MWH Ref: z1449801

Greater Wellington Regional Council  
PO Box 41  
MASTERTON

#### **Additional Comments in response to Greater Wellington officer comments**

#### **Water Take Application**

MAIRARAPA AGRAGGREGATES KIMI LUMBER SITE		NOT FOR CONSTRUCTION	
FOR REVIEW		Drawn Date	19/05/2008
PROPOSED EXCAVATION LIMITS & WATER MANAGEMENT PLAN FIGURE 3		Scales (A1) 1:1000 (A3) 1:2000	
MWH		Drawn No.	Z144.9801
REV		Rev	D

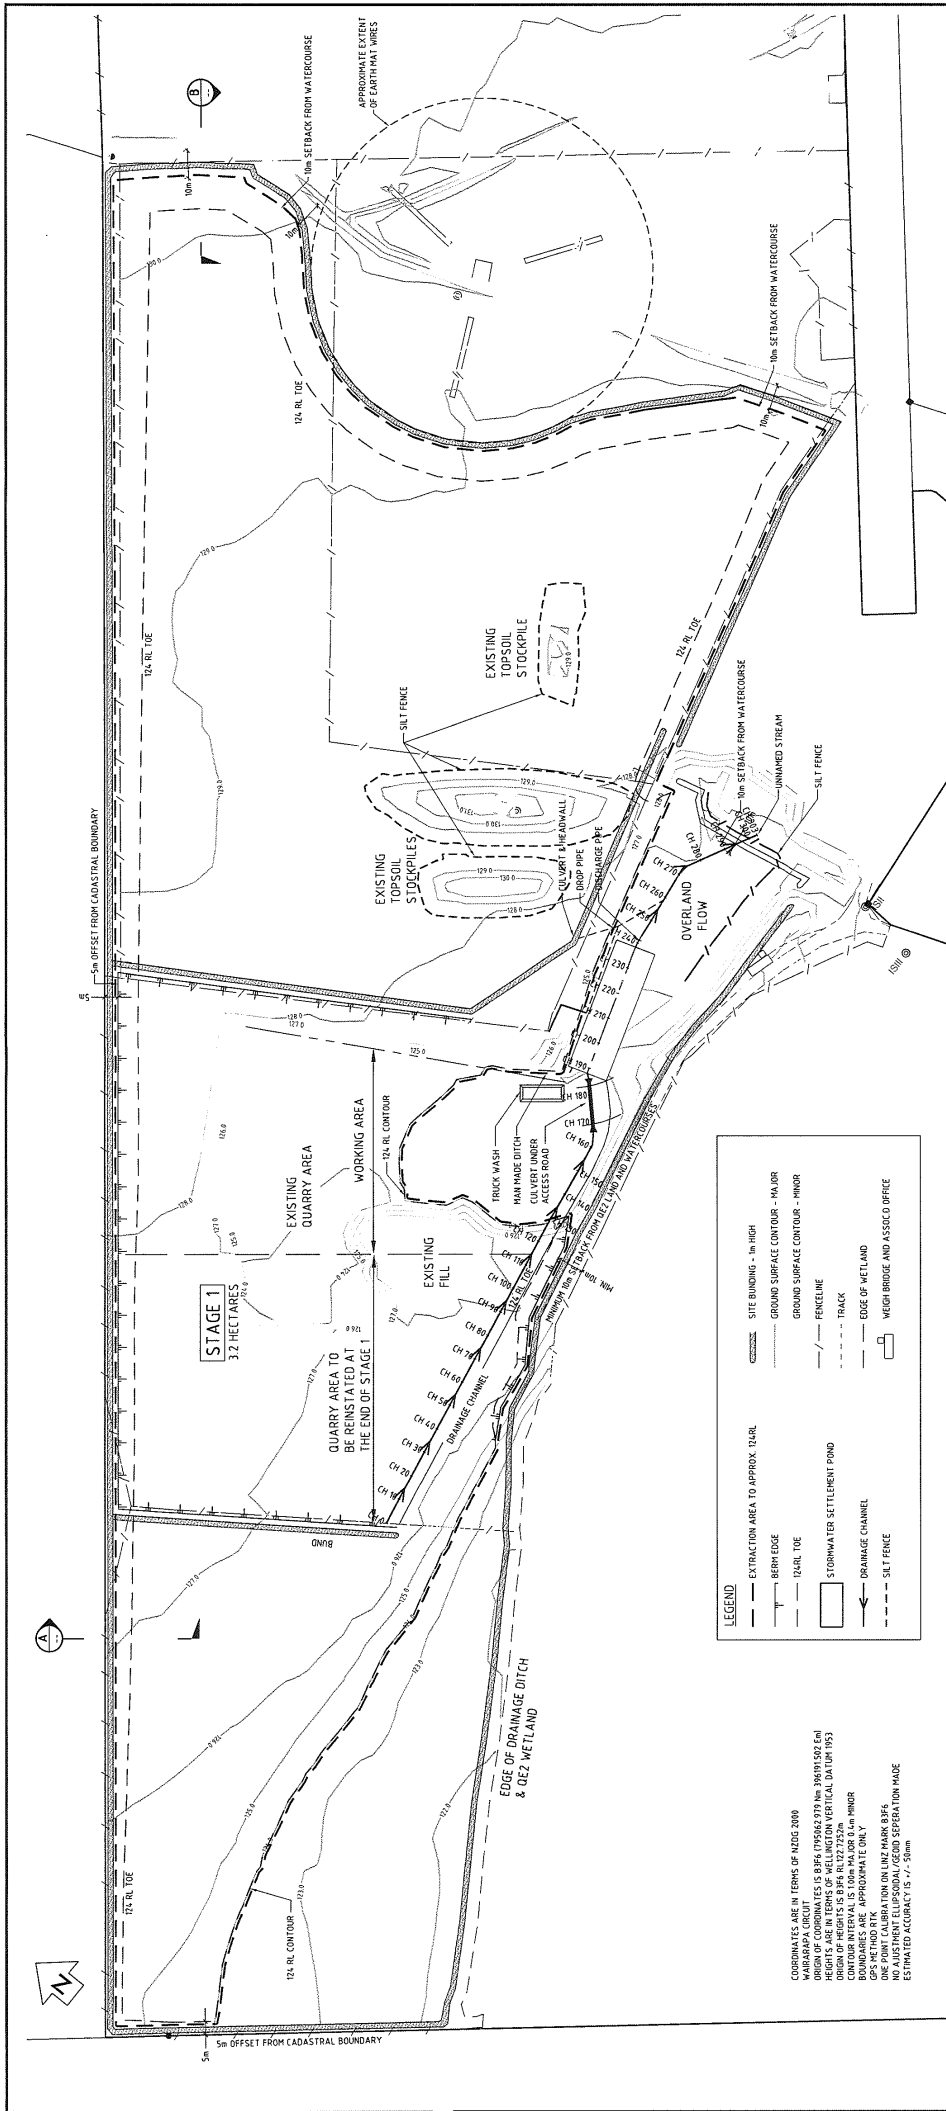
- ***Appendix A has not been updated to show that no extraction is planned below g/w level***
- ***1.3 "Quarry run-off will be controlled by a sediment control pond excavated below the current quarry floor level of 124m, into the water table." In other words this will be a well for which a bore permit is required! Is it necessary to excavate into the water table and if so how is g/w water quality to be maintained? "small area of wetland and some drains" actually there is a spring with very clean water which should be preserved***
- ***Excavation in 3 stages – this is not sufficient restriction of size of area exposed at any one time as stated above***
- ***Truck Wash and filtration system – no mention of how contaminants from truckwash will be kept from entering waterways***

Bullet point 1 - We apologise for attaching an earlier version on the plan in Appendix A. Please replace GE01 Rev B with GE01 Rev D. A copy of plan GE01 Rev D is enclosed at A1 and A3. Correct copies have also been sent to Carterton District Council.

DATE: 28/01/2009  
 DRAWN: Z1449801  
 SHEET No: C04  
 REV: A

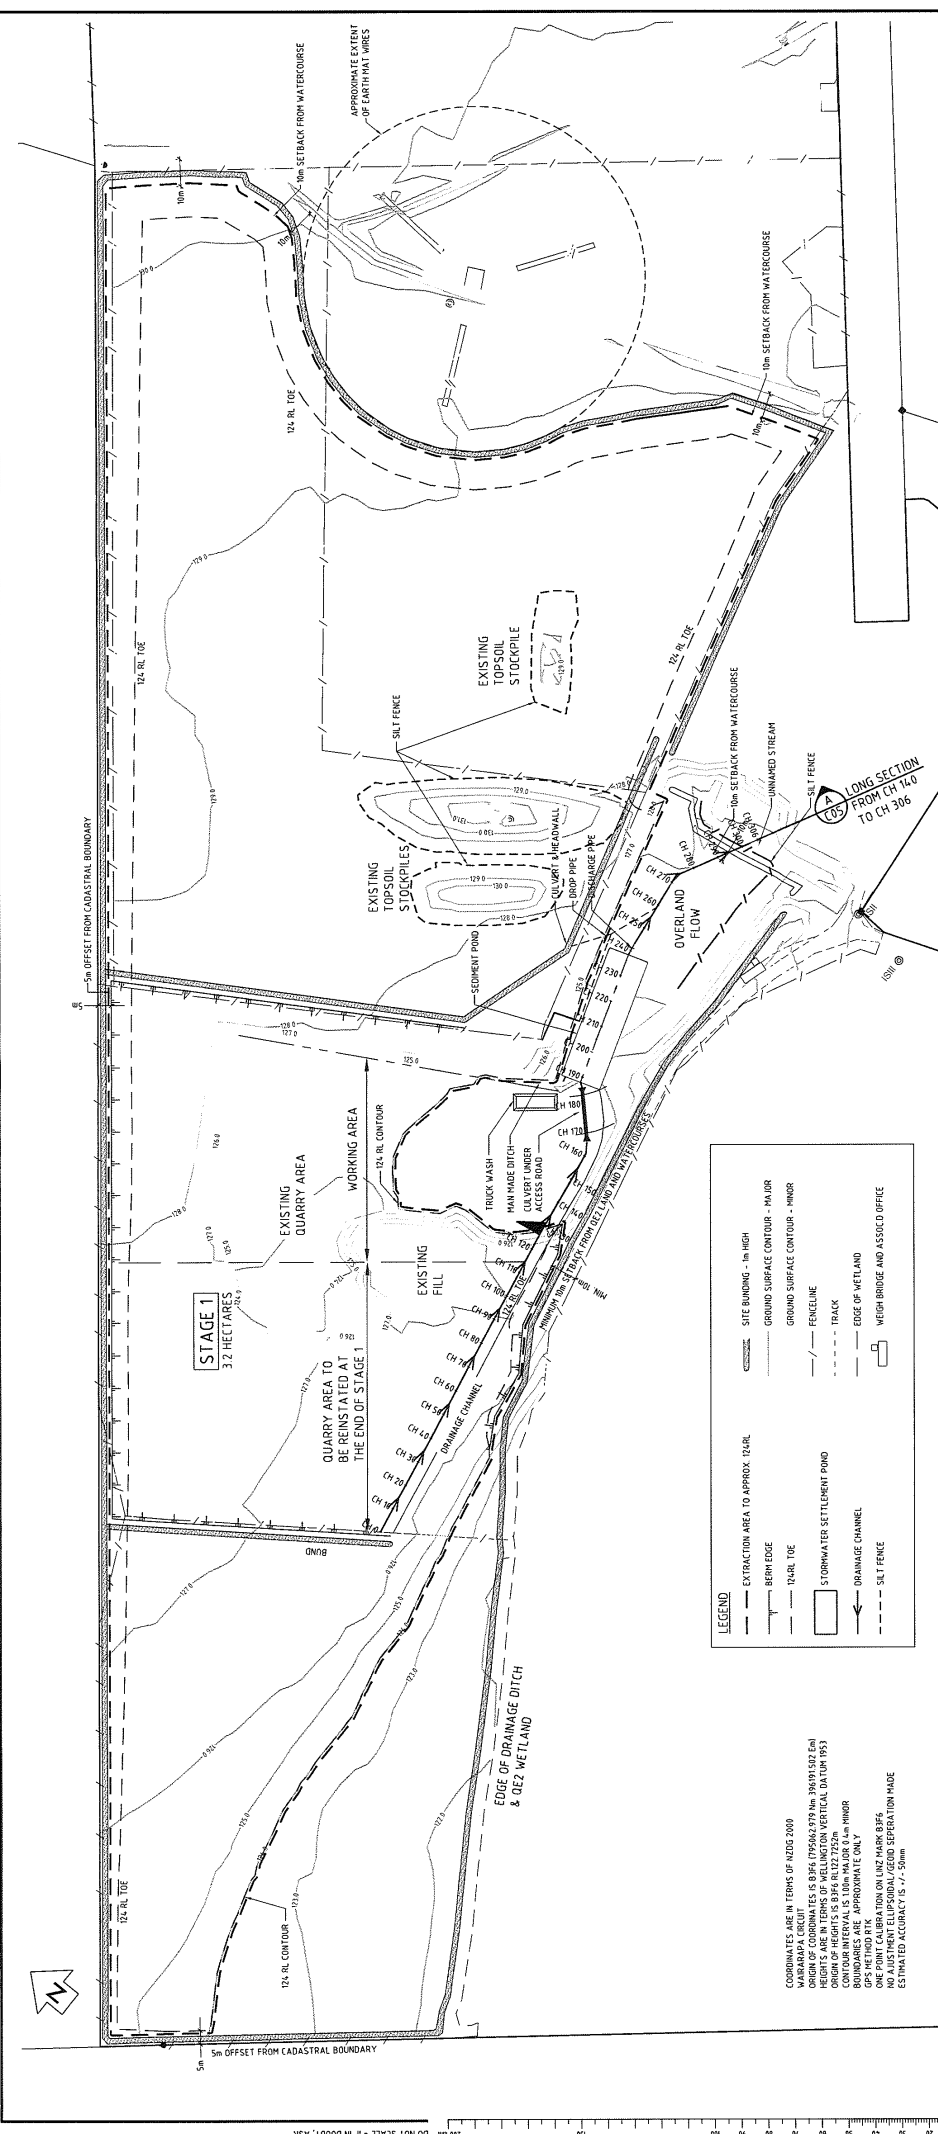
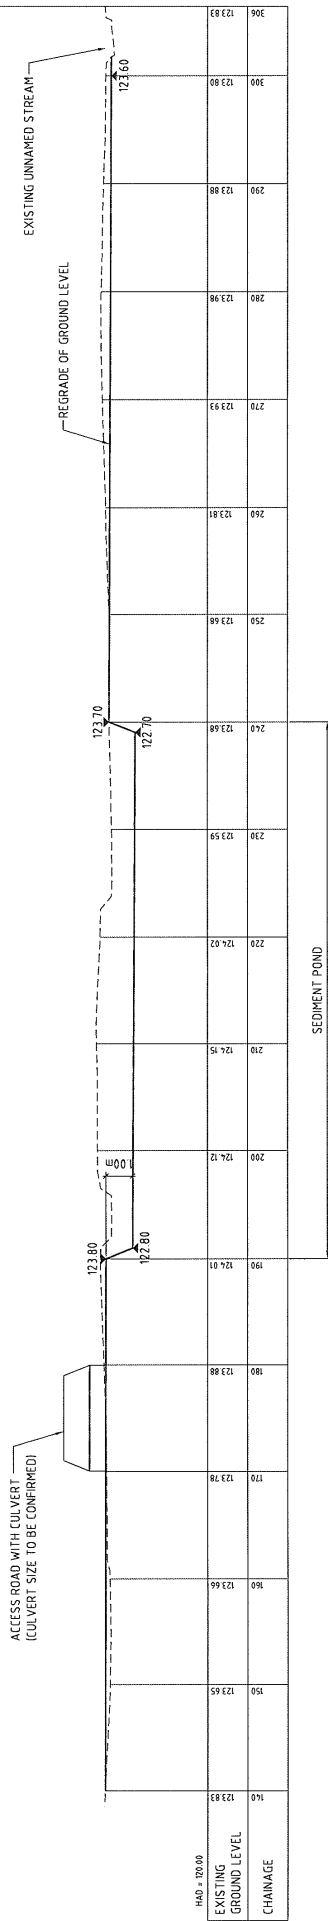
- **Note interception of groundwater during quarrying or making a settlement pond would require a further consent – essentially another bore permit – We cannot proceed to notification if further consents are required**

Bullet point 2 - We have reviewed the design of the settlement pond, which is shown as having a slight fall of "natural ground level" (in reality a formerly excavated surface) across its length. A long section is provided (Sheet C04 & C05 Rev A). A level surface is required for maximum settlement, so either slight excavation, or a combination of bunding and excavation may be necessary. Therefore we have provided a further Application Form to cover off the possible need to excavate below the current ground surface. The need for this consent would only be clarified at the stage of finalising the Erosion and Sediment Control Plan, and therefore undertaken as part of meeting a condition of consent. Thus the form is provided on a precautionary basis. Any effects would be de minimis, due to the relatively small area and limited depth involved (up to 1m over part or possibly all of the area of the sediment pond), and the intention to consult closely with GW while preparing the Erosion and Sediment Control Plan. The assessment of effects for this additional subsidiary consent should be considered as part of the consents for the intended quarry operation as a whole, and described in relation to the AEEs provided in association with the other consent applications.
